Access Compliance Report Public Rights-of-Way (Curb Ramps)

Main Street: MEANDERING_TRAIL		Cross Street: STARLIGHT_RIDGE		Location:	SW
ADA ID: RPRK211018181126	Ramp Type:Type 1 - Perpendicular	Initial Pass/Fail: Fail	Overall Compliance: No	Severity Score:	16
Codes/Mitigation Info/Possible Solution			Field Measurements/Component Compliance

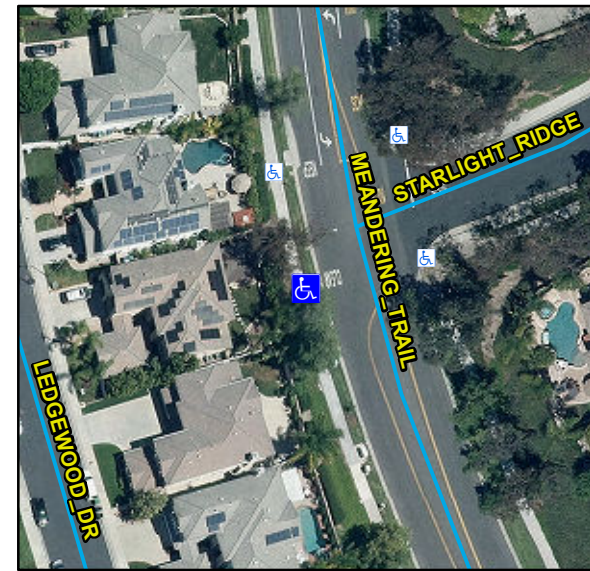
R304.2.2, R204.3, STD 1115

Remove & Replace Entire Ramp.
